**RE: REF 20/2023
BROKEN HILL HOSPITAL REDEVELOPMENT PROJECT
ADDENDUM #1 TO APPROVED REF**

This letter serves as Addendum #1 to the approved Broken Hill Hospital Redevelopment REF (REF 20/2023). REF 20/2023 was approved by HI on 12 December 2023.

Figure 1 – Proposed (above) and approved (below) west elevation of the ED extension and ambulance bay roof (STH)

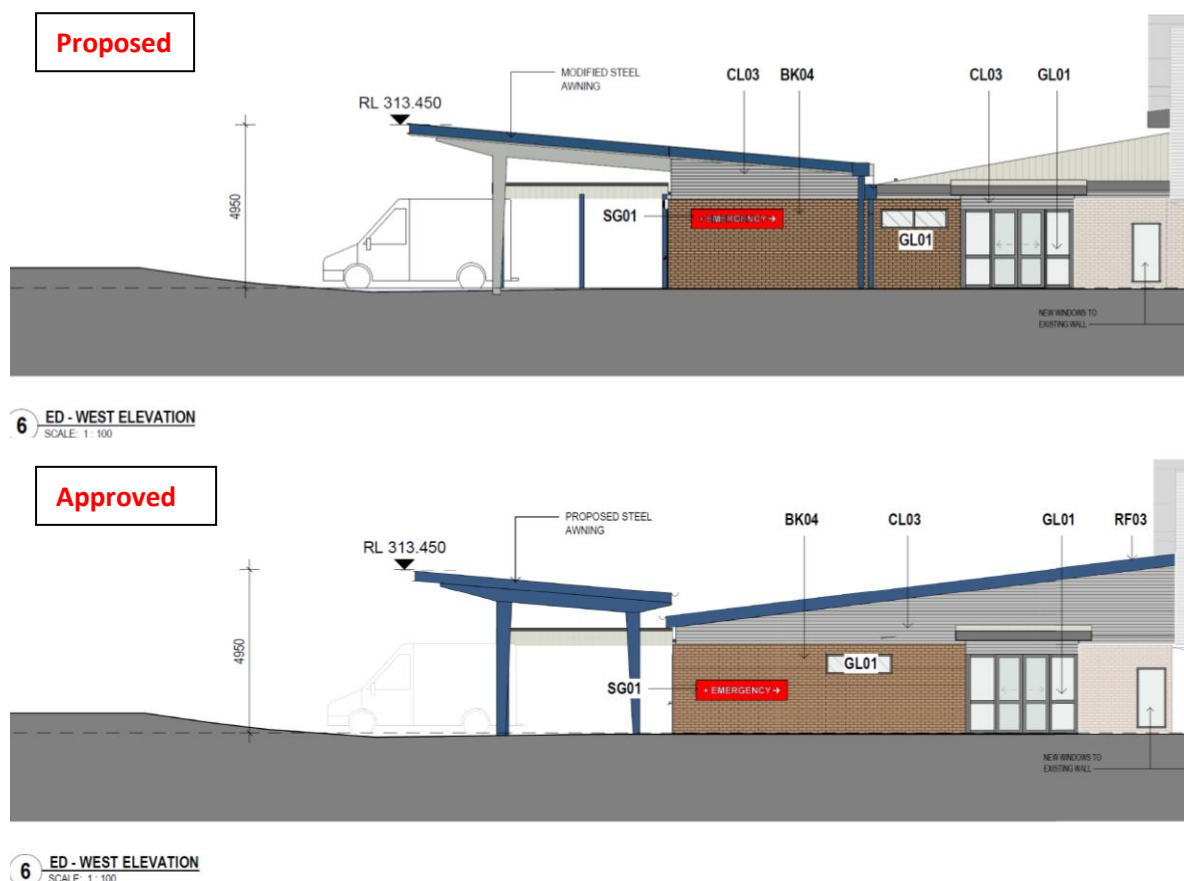
- Retaining the original ambulance bay roof adjacent to the ED. The proposal maintains the approved extension of the ED, however the approved new ambulance bay roof has been deleted in favour of building under the existing roof canopy (see **Figures 1** and **2**).
- Replacing the approved rammed earth wall finish on the MHU with a rendered brick finish.

Renders of the approved and proposed for these items are included at **Figures 2** and **3**. **Figure 4** shows an extract of the approved and proposed materials and finishes.

Figure 5 – Proposed location of the new relocated Disaster Store (STH)

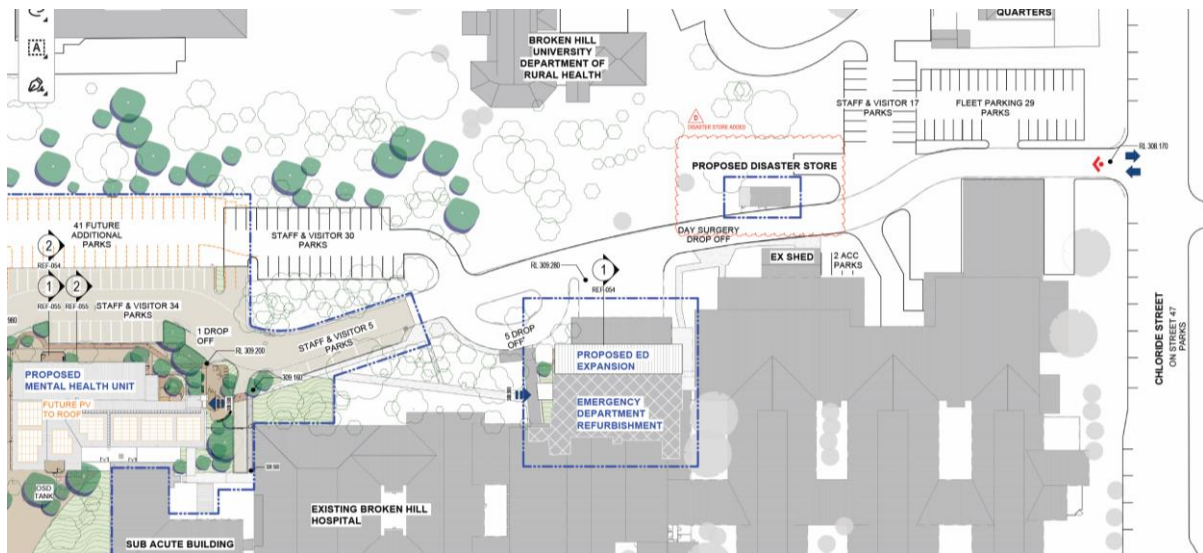
The proposed relocated Disaster Store will be placed adjacent to an existing plantroom opposite the existing ambulance bay in proximity of the ED. See the location in **Figures 5** and **6**, as well as an elevation in **Figure 7**. The works associated with the relocation include minor earthworks and a new slab. The Disaster Store will be separately air-conditioned to ensure a controlled environment is provided. The building is a single storey in rise and will not result in any tree removal.
